MODEL: <b>J &amp; D Series</b>	TYPE: <b>Field Change Program</b>	SECTION/GROUP: <b>03- Body</b>	DATE: <b>June 18, 2019</b>
-----------------------------------	--------------------------------------	-----------------------------------	-------------------------------

Ref. MCI NHTSA Recall No.: 19V-344  
Specialty Manufacturing, Inc. NHTSA Recall No.: 19E-017

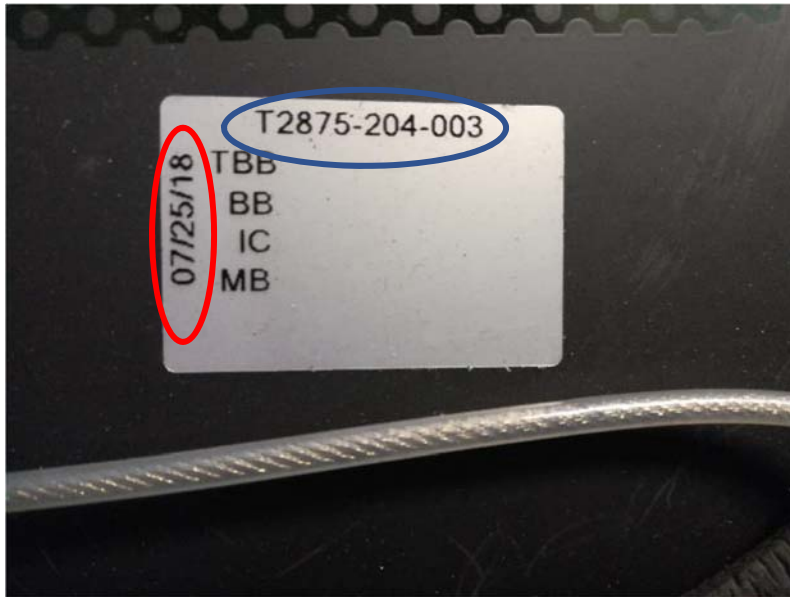
Check the label on the bottom of the Transpec Glass Hatch p/n T28XX-XXX-XXX (circled below in blue) for dates between August 1, 2018 and February 22, 2019 (circled below in red). Units built within this date range are subject to the replacement campaign.
